From: Hoellman, Jordan
Sent: Tuesday, September 06, 2016 2:37 PM
To: Vogle PEmails
Subject: Pre-Submittal Presentation for LAR 16-024, "Column Line 7.3 Wall Reinforcement Area Change"
Attachments: 2016-09-08 LAR 16-024 Pre-Submittal Presentation.pdf

LAR-16-024: Column Line 7.3 Wall Reinforcement Area Change Pre-Submittal Meeting

September 8, 2016

Wall 7.3 Reinforcement at El. 82'-6" (south side)

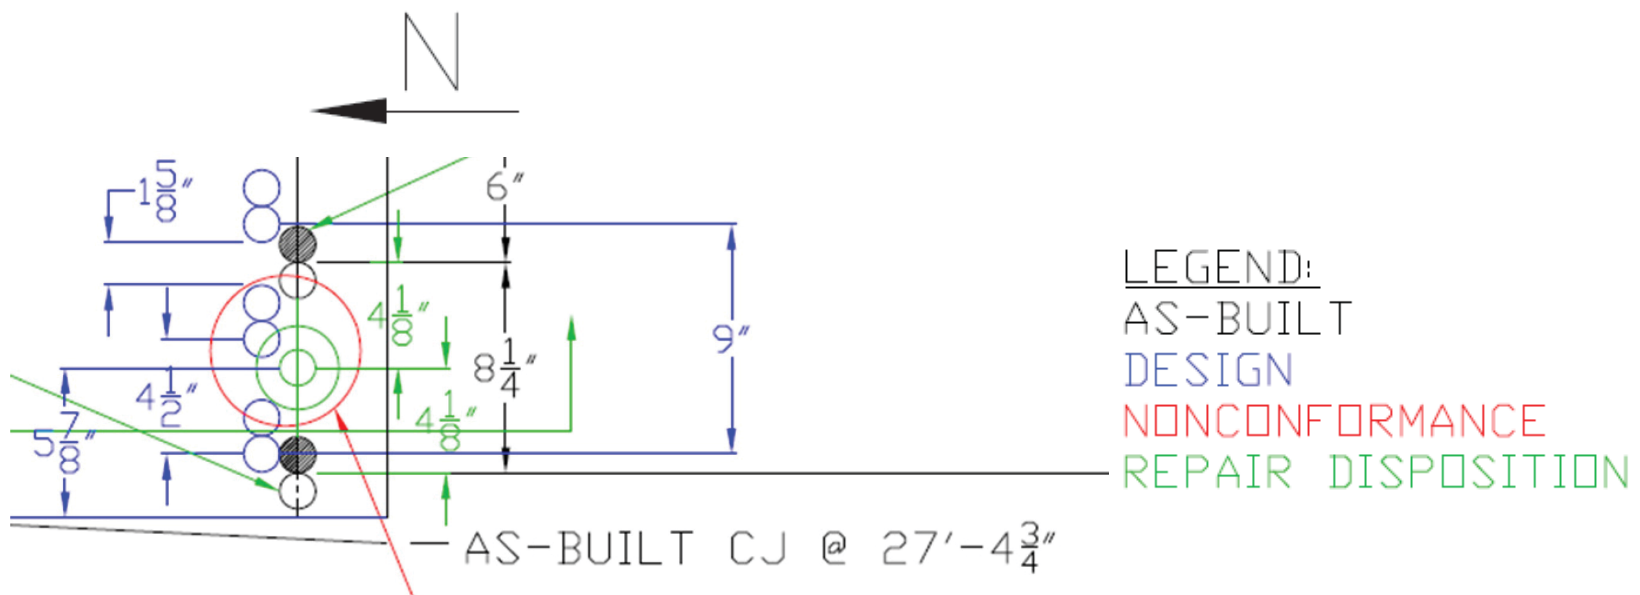
- Contrary to UFSAR Table 3H.5-5, one #11 dowel was omitted due to congestion at the west end of the south face of Wall 7.3, resulting in 54 bars and providing a vertical reinforcement area of steel of 3.08 in²/ft.
- The condition was entered into the corrective action and nonconformance programs. The site-specific design change which caused this omission is applicable to both units.

Red line indicates location
where dowel is missing.

- Licensing Basis Change:
 - LAR-16-024 proposes to reduce the provided minimum reinforcement from 3.12 in²/ft to 3.08 in²/ft for this location.
- The interaction ratio (IR) for wall section 11 is 0.667 where the required reinforcement per UFSAR Table 3H.5-5 is 2.08 in²/ft and provided reinforcement is 3.12 in²/ft. After the addition of a headed reinforcing bar on the south face, the provided reinforcement is reduced to 3.08 in²/ft along the development length of the bar from elevation 82'-6" on the column line 7.3 wall. The new IR for this section of wall is .675, an increase of only .008 in IR.

- Additionally, the detailed analysis found that the local reinforcement required by design in this region is 0.997 in²/ft while the provided reinforcement locally would be 2.08 in²/ft without a developed bar.
